NUMBER: SB 500-27-004, Rev C
MODEL: ECLIPSE EA500
SUBJECT: Aileron Joint Assembly Inspection and Replacement

Possible corrosion of the Aileron joint assembly bearing or shaft resulting in aileron friction being out of tolerance. Corrective action is to inspect aileron joint and replace with redesigned parts.

**Aileron Joint
Figure 1**

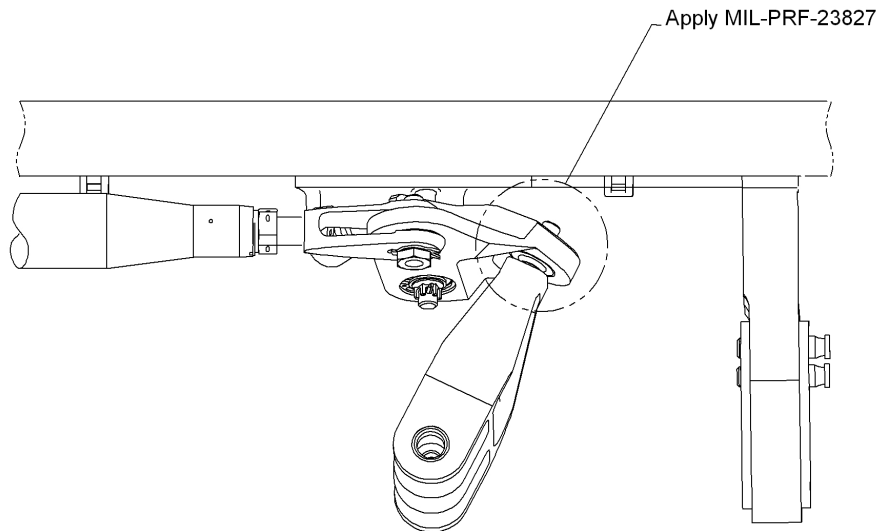
- (1) Make sure bearing and pin is clean and dry, apply ROYCO 27 (MIL-PRF-23827 or equivalent) around the pin and bearing area ([Figure 1](#)) after initial inspection. Reapply every 100 hours subsequent. Refer to AMM 20-10-00-051-911-005 CORROSION PREVENTION.
